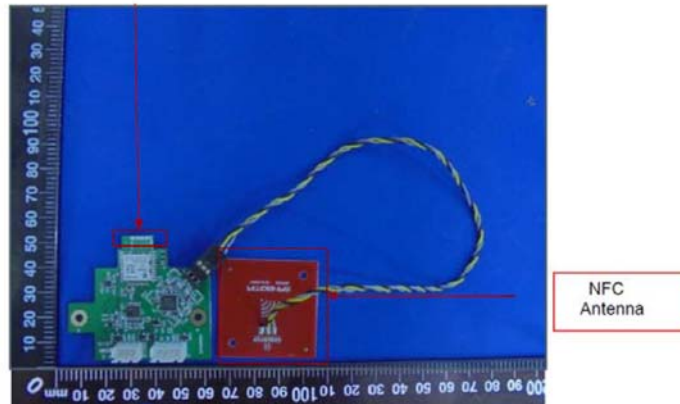
- 5) Please confirm the same antenna element was used as the original approval. The original shows:

Also note that the NFC output level was significantly reduced by the addition of the dampening resistor added to the antenna. The coil has remained the same.
